Proposed Design Amendments

2.3 Eco Lodge at Robertsmere Lake

ERECTARCHITECTURE				
Drawing Issue Sheet				
Project	22402			
	Reinventing Borde Hill			
				20
				11
			Date	25
Reason for Issue	I - Information P - Planning T - Tender C - Construction			S73
Issue Format	E - Electronic H - Hard copy B - Both			E
Distribution	Client - Borde Hill Gardens			x
	Arborist- Arbotrack			x
	Ecologist- Arbtech			x
	Landscape Architect - Hortus Collective			
	Structural Engineer - Allt Environmental			
	MEP Engineer & Sustainability Consultant - BTP			
	Cost Consultant - Mc Convilles			x
	Planning Consultant- Whaleback			
	Planning Authority			x
	Building Control

Illustrative sketch of the Eco Lodge approaching from the east

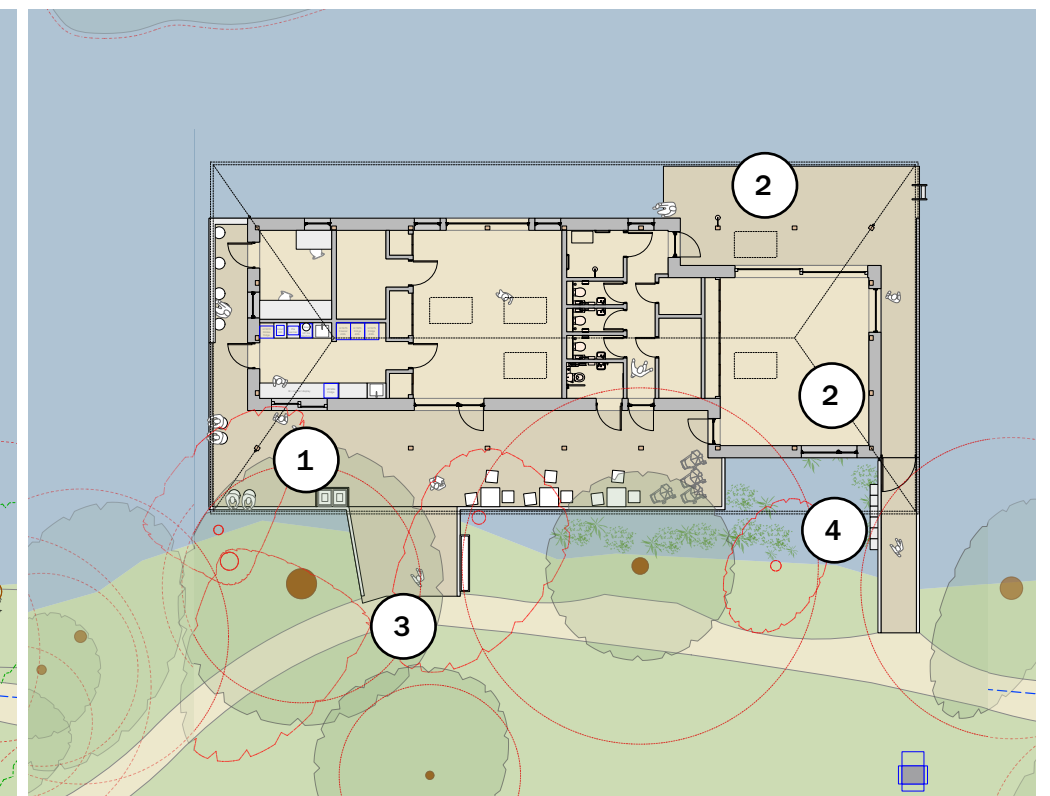
- 1 The reduction of the café deck which was requested during the planning process led to a review of circulation for servicing space and outdoor seating space.
- 2 Due to daylight and overheating calculations, fenestration changes were made to the walls and a rooflight has been inserted into the canopy of the wellbeing deck
- 3 The ramp and seating configuration to the south west of the building has been slightly amended to work better with the existing topography and change to respond to the removal of the café decking.
- 4 The reduction in size of the decking has also meant that changes were made to the location of the lockers for the swimming area.

2.3 Eco Lodge at Robertsmere Lake cont.

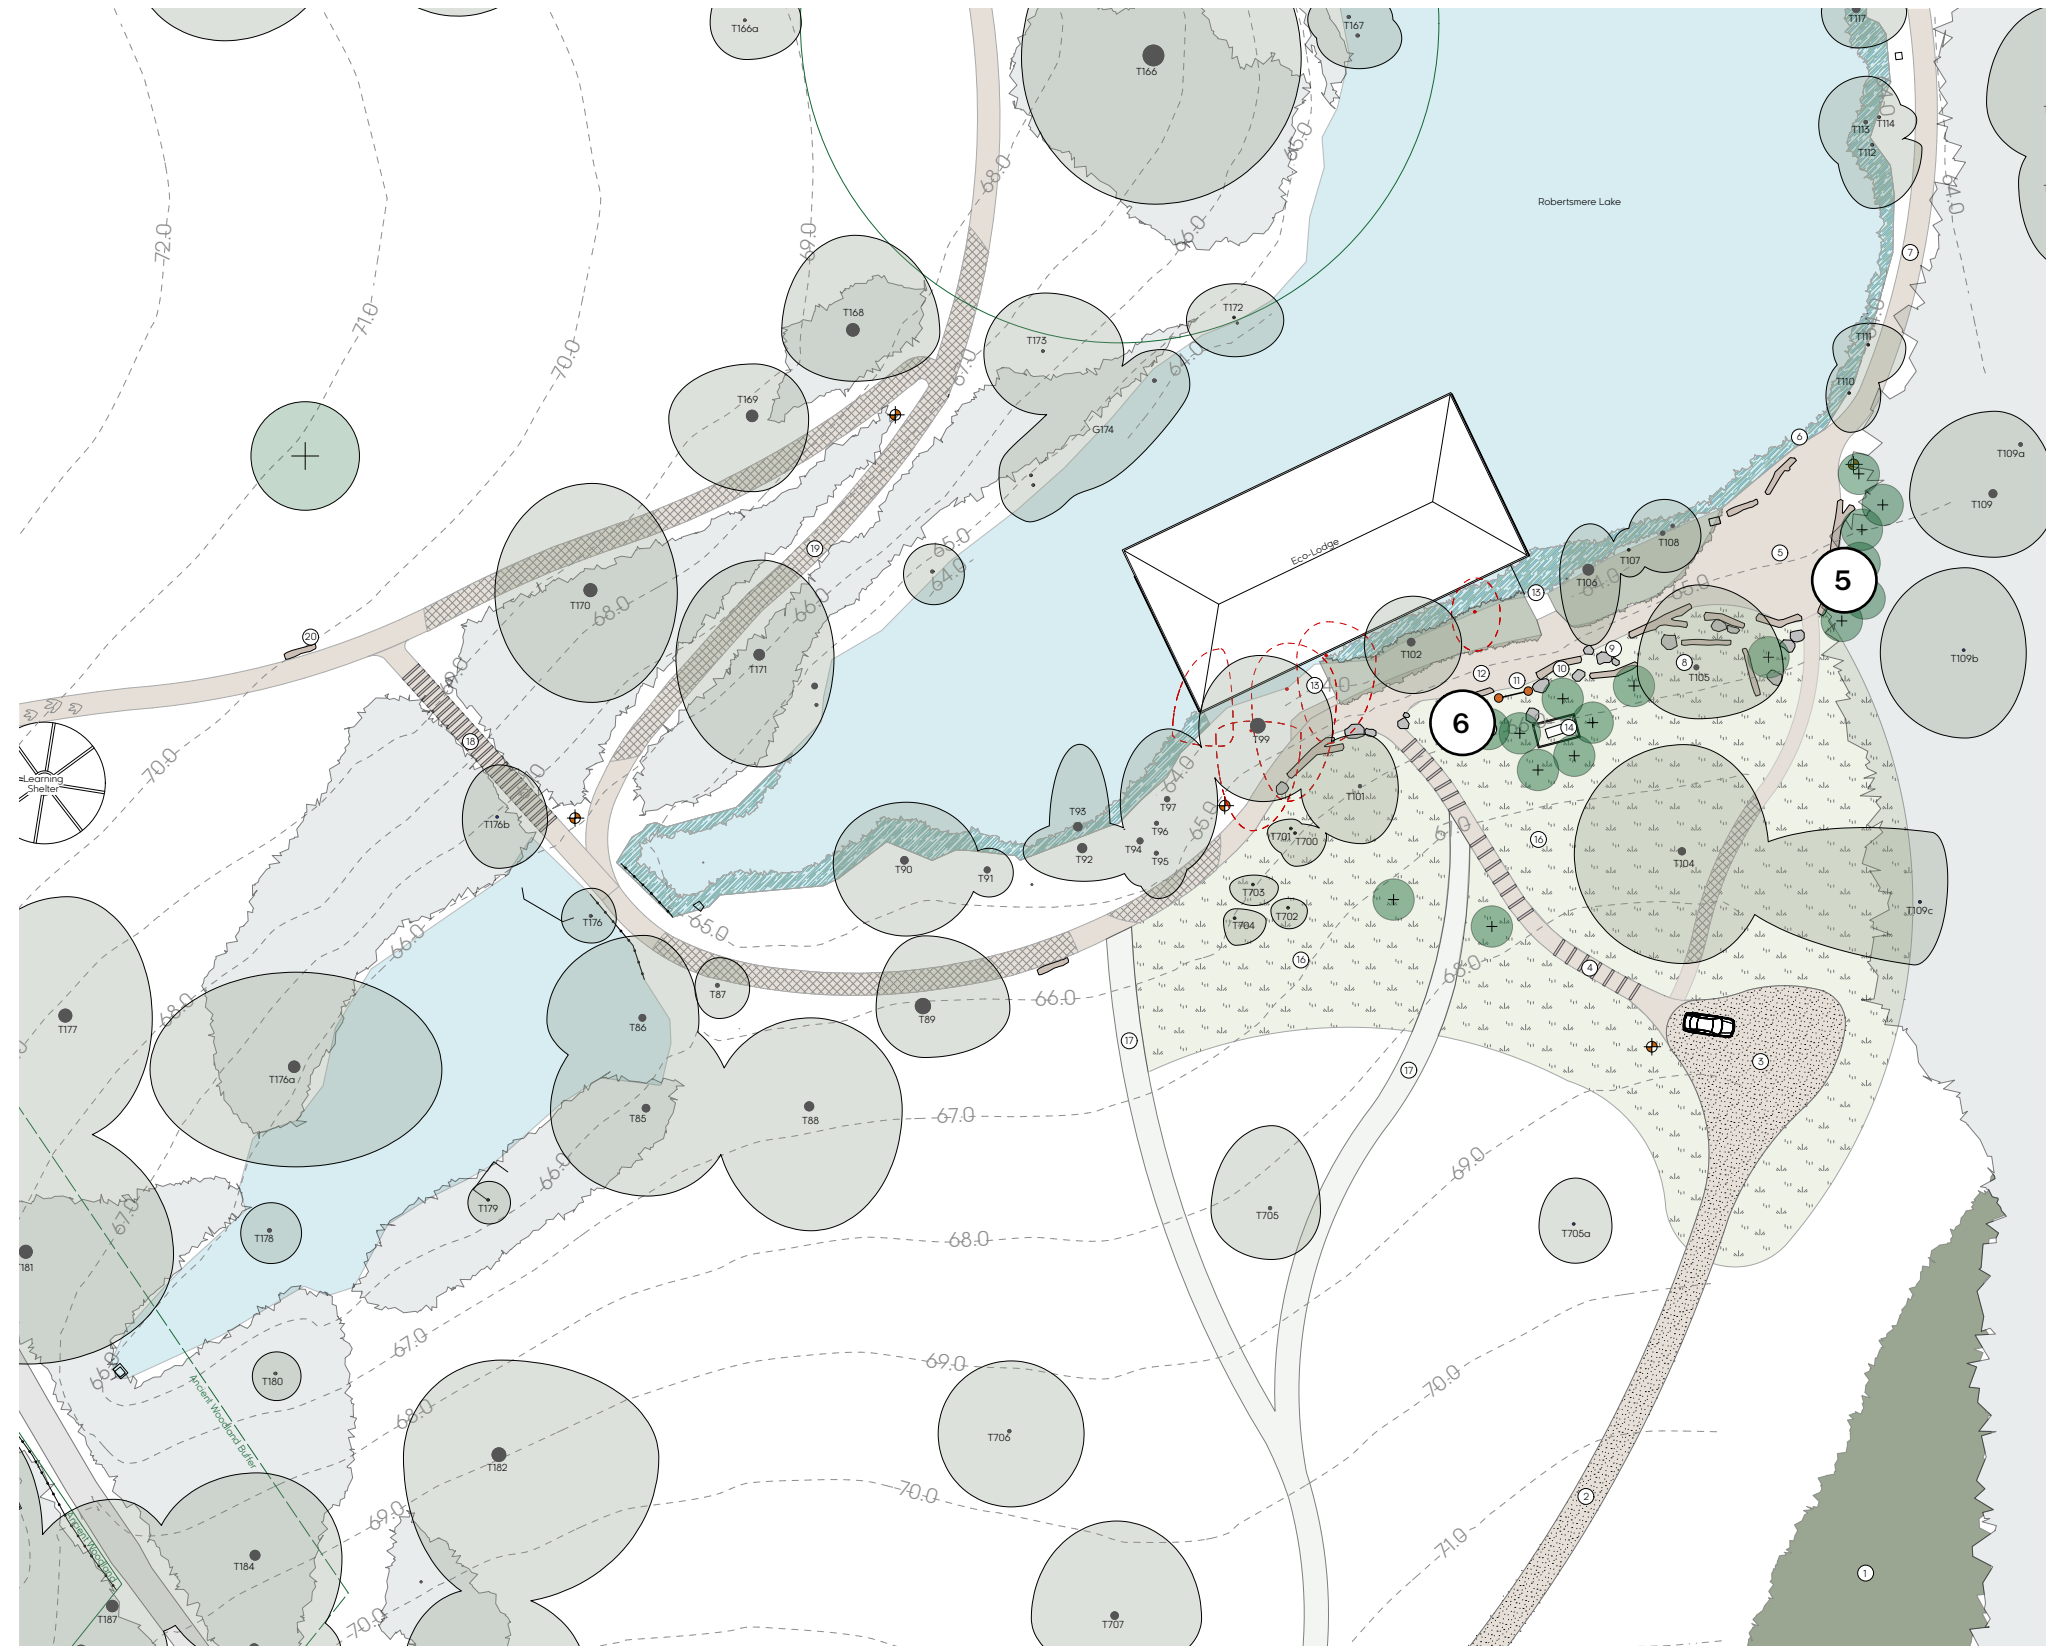
- 5 Adjustment of the light vehicle access track and turning head for the Eco Lodge
- 6 Further design of Eco Lodge entrance and surrounding seating areas.

2.3 Eco Lodge at Robertsmere Lake cont.

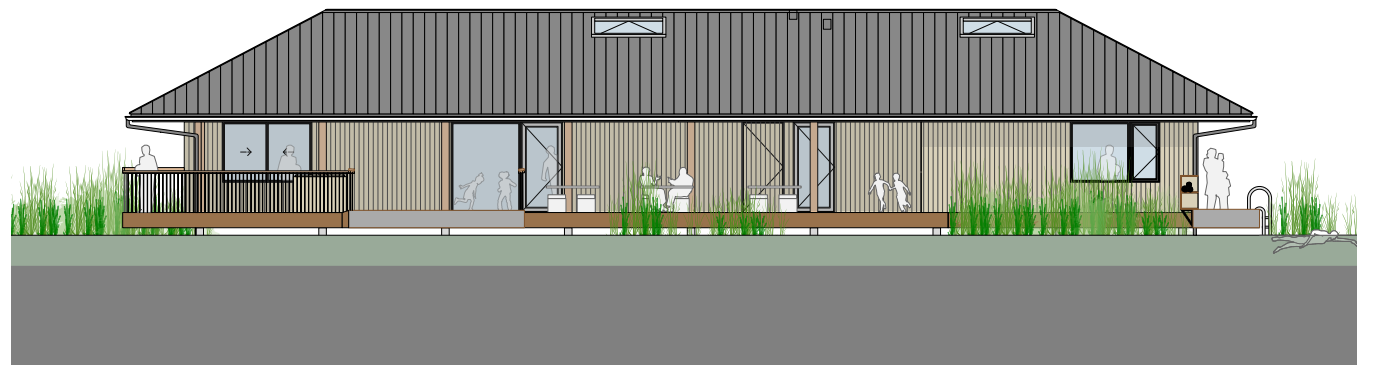
Consented North Elevation

Proposed North Elevation

Consented South Elevation

Proposed South Elevation
